# PLANNING COMMISSION STAFF REPORT

## LAUREL RANCH GAS STATION

SW Corner of Laurel Rd. & Country Hills Dr./APN: 053-060-064  
PDP-22-01

**PRELIMINARY DEVELOPMENT PLAN**

ENLARGED SITE PLAN  
1" = 20'

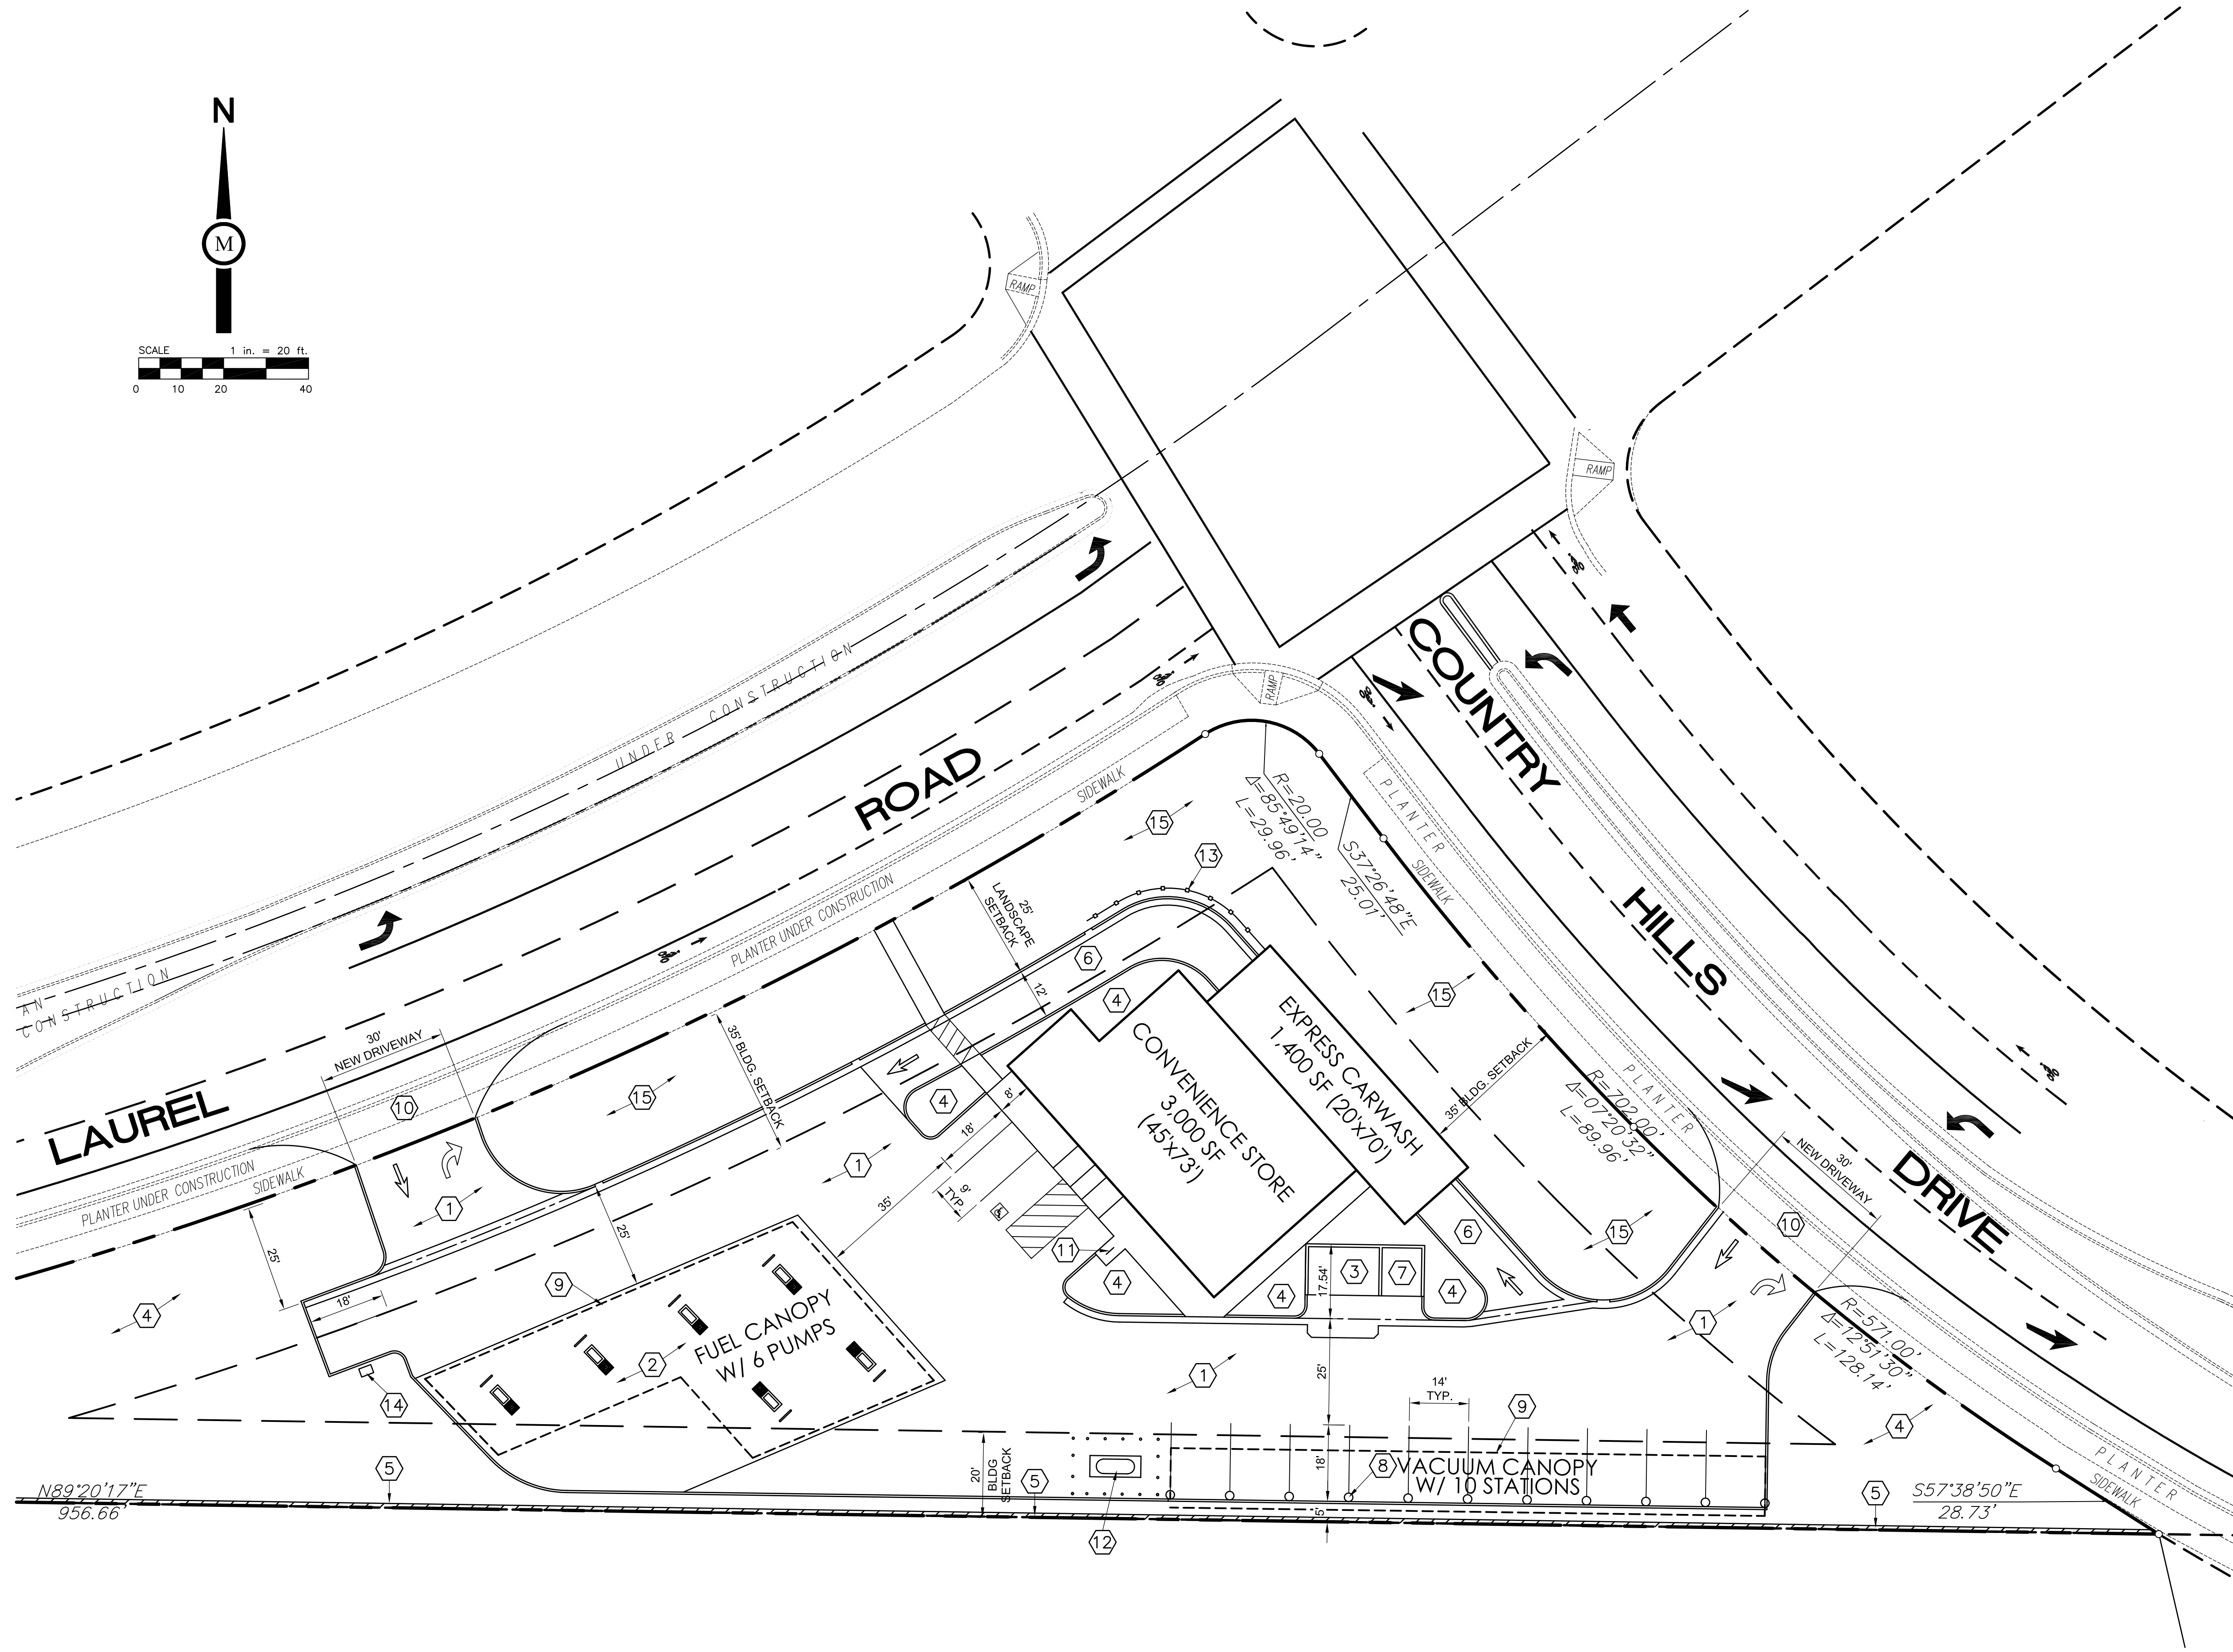
The shared convenience store and vacuum parking may create on-site congestion for customers waiting to use the vacuum stalls. Staff recommends that the convenience store parking be provided in substantial compliance pursuant to the standard parking requirements, a total of 16 off-street spaces.

Staff has several concerns related to the layout and access to the site. As described above, the canopy encroaches into the property's rear setback of twenty feet. While the AMC service station

section requires a minimum setback of 5 feet from any interior property line, the code also does not state that encroachments into a larger, required setback may be granted. Given the site's proximity to residential uses, staff believes the canopy should not encroach into the required setback.

- Provide a stronger architectural design along the Laurel Road frontage to be consistent with the design guidelines and ELTSP.
- Redesign the site to remove the canopy encroachment from the rear setback, provide the required parking in dedicated parking spaces not reserved for vacuums, and relocate the vacuums away from the residential use.
- Follow the recommendation in the Transportation Study and reverse the direction of the carwash.
- Provide landscaping consistent with the rest of the site in the area currently shown as hydroseed.

PRELIMINARY GRADING & DRAINAGE PLAN  
1" = 20'

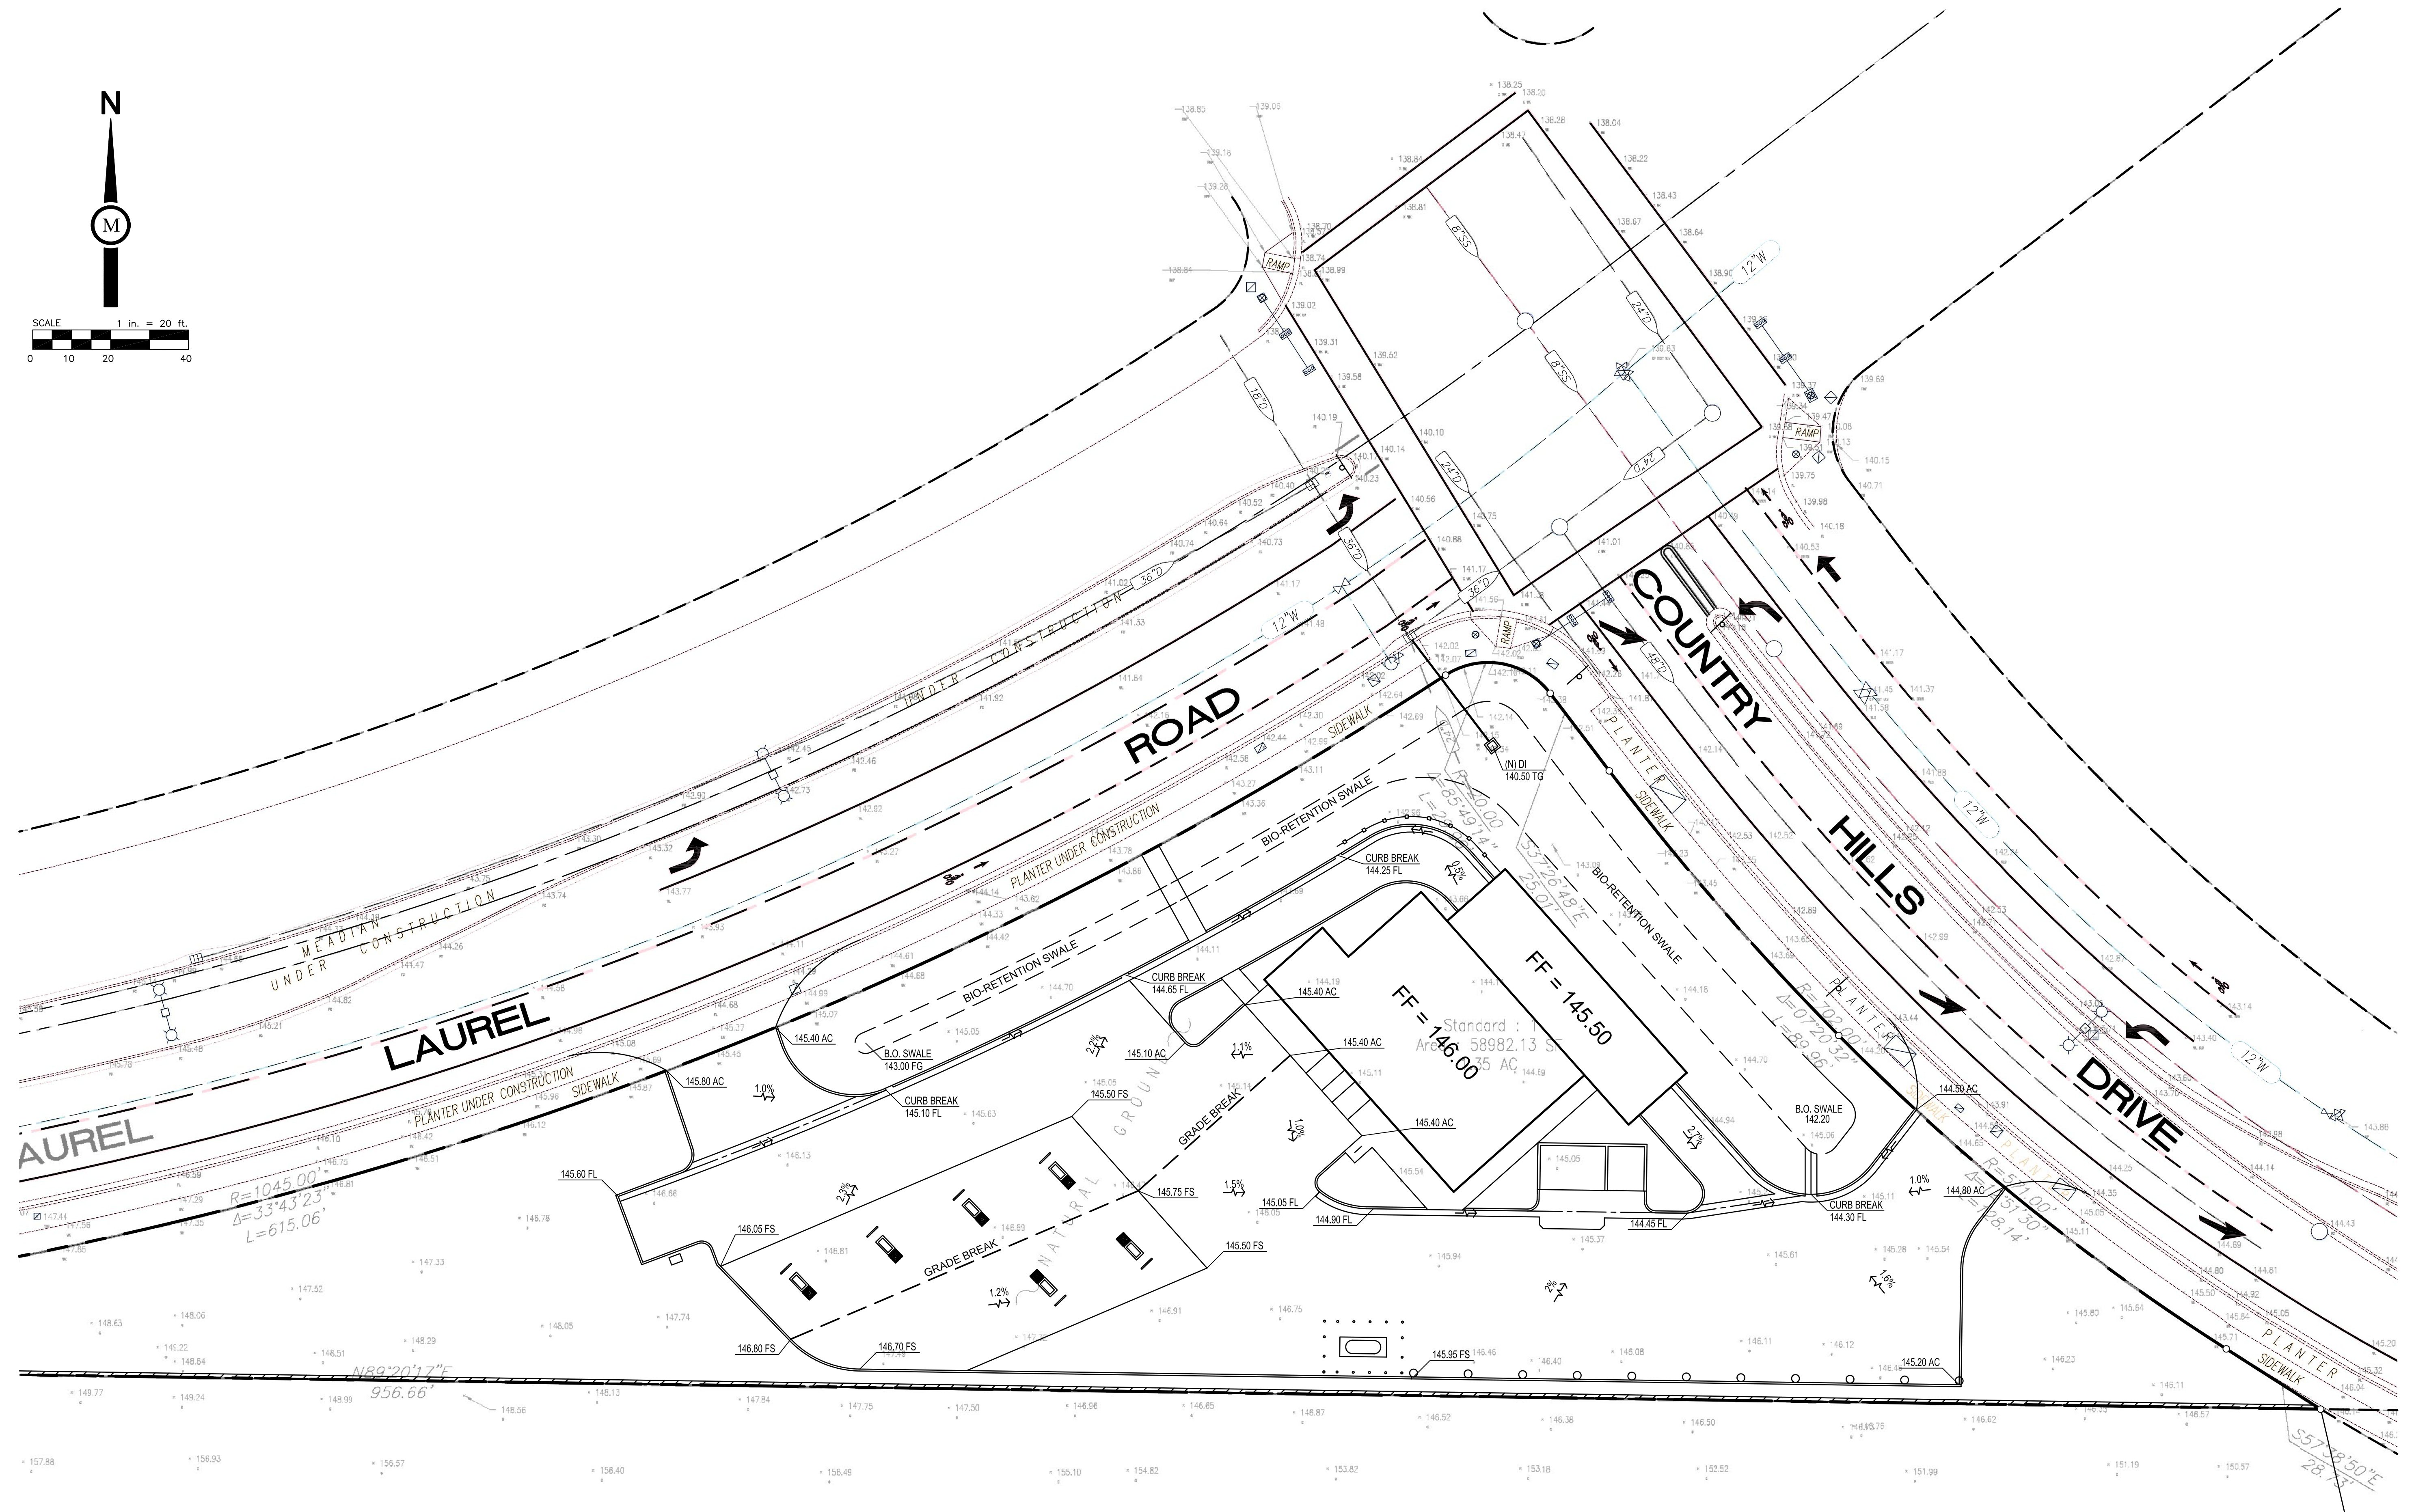
- Based on the 45 MPH speed of Laurel Road, a wider approach and/or turn pocket may be needed.
- The details on sheet 1.2 are very faint and can't be read.

Figure 2  
Site Plan

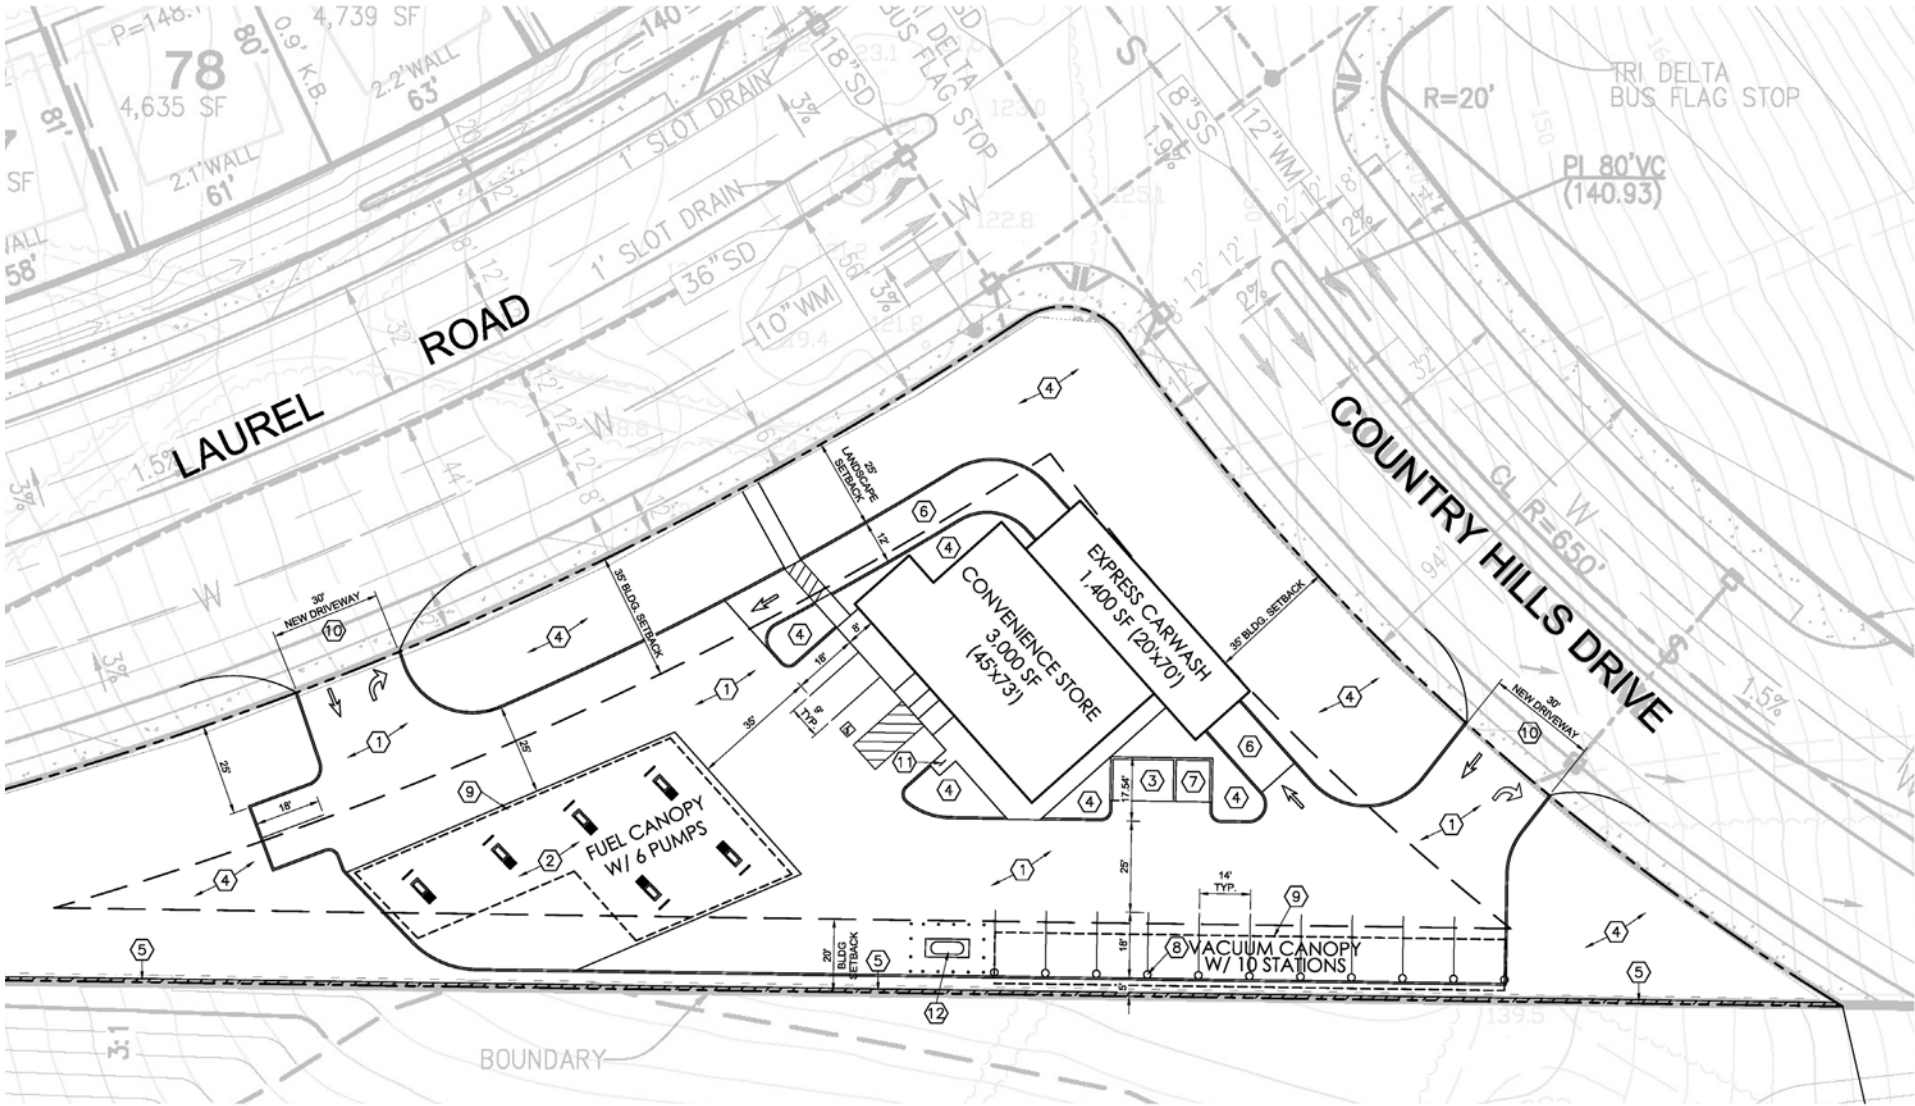
The site plan shows carwash queuing space for approximately three vehicles. Any queue longer than three vehicles may block the drive aisle/driveway along Country Hills Drive. Hexagon recommends that the direction of the carwash be reversed so that vehicles traverse the carwash from north to south. This will allow queuing space for approximately six vehicles, and the carwash queue would form along the north side of the project site. This would reduce the likelihood of queues encroaching on the drive aisle and driveways.

**ATTACHMENT E  
QUEING MANAGEMENT PLAN  
(SEPARATE PAGE)**

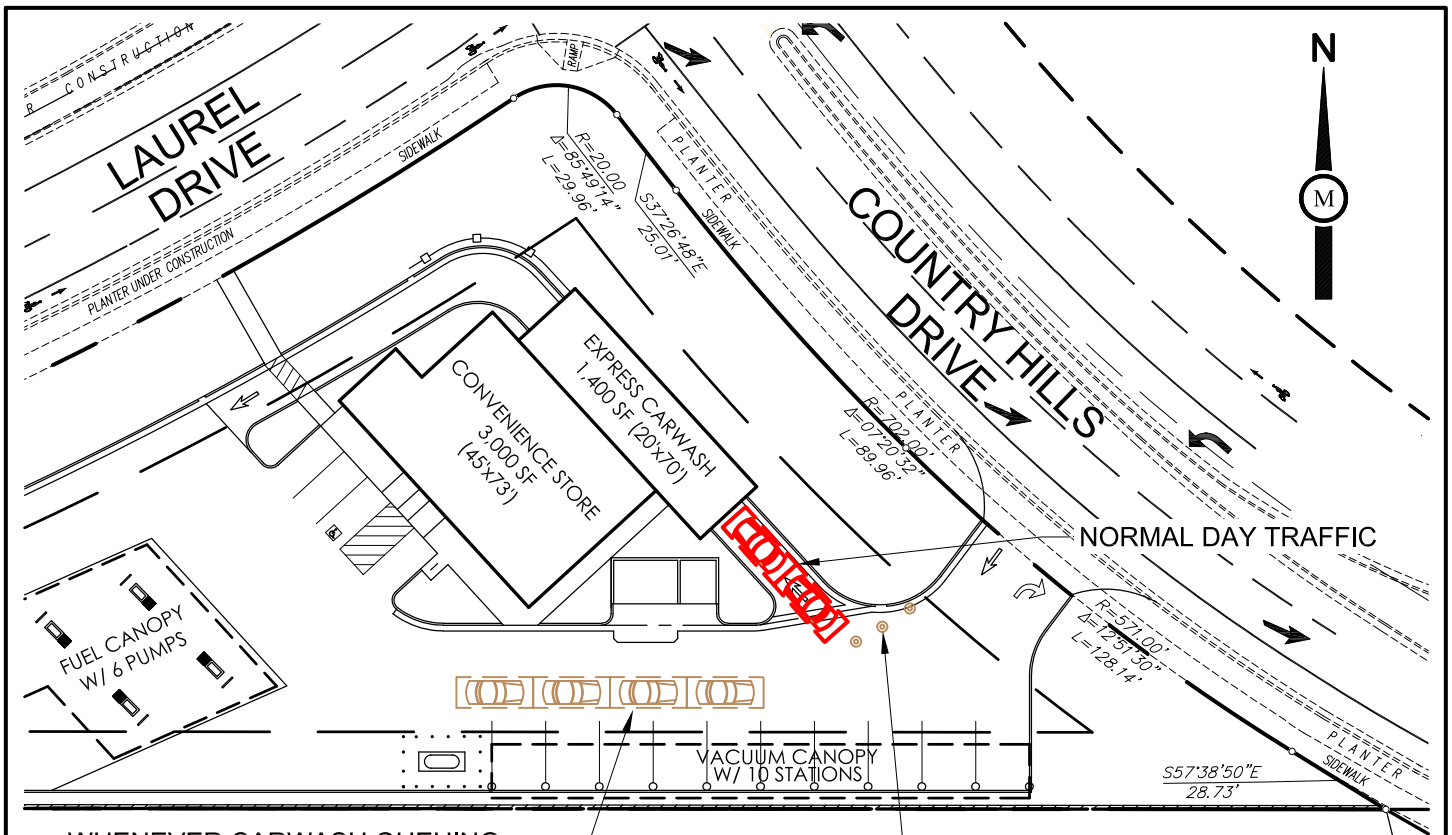
- Staff is concerned about planting ivy on the wall along the southern property line.
- **Traffic Engineering Comments**
  - The Queuing Management Plan prepared by Milestone Associates is NOT approved. They cannot move forward with their proposed plan for queuing.
